September 1, 2020

Site: Sevano Place Subdivision – C18E075 Louisiana Blvd/ Alameda Blvd

Re: Drainage Ordinance (14-5-2-1) Violations

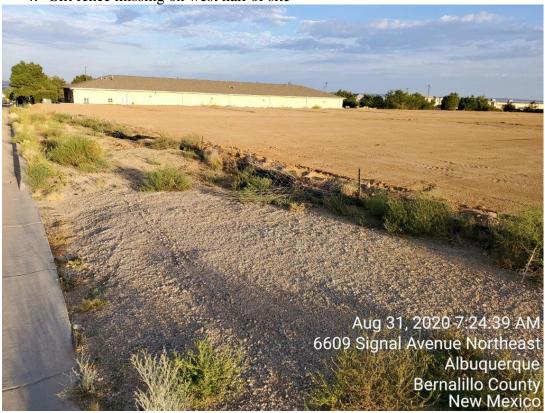
- 1. The NPDES coverage, NMR 12B517, expired.
- 2. East construction entrance does not extend all of the way to paving, is covered with dirt, and has had trackout for 5 days.

3. West construction entrance missing and has had trackout for 7 days

4. Silt fence missing on west half of site

5. Silt fence is not embedded and is too far from paved road east half of site.

6. NPDES permit coverage was not posted on the property.

- 1. The property owner's NOI(s) must be submitted and approved by the City.
- 2. The Erosion and Sediment Control Plan must be updated and submitted to the City for approval. The site has been graded to drain the planned lots to the planned streets which discharge concentrated flow to the MS4 in two places (north and south). The ESC Plan must be modified to add appropriately sized sediment traps at the two points of discharge with construction entrance(s) located uphill from the south pond. Maintain BMPs until site is stabilized.
- 3. Remove sediment from the adjacent streets and sidewalks the same day that it occurs.
- 4. Install and Maintain BMPs until f stabilized.

- 5. Provide self-inspection reports until the site is stabilized.
- 6. Post NPDES coverage for safe public viewing.
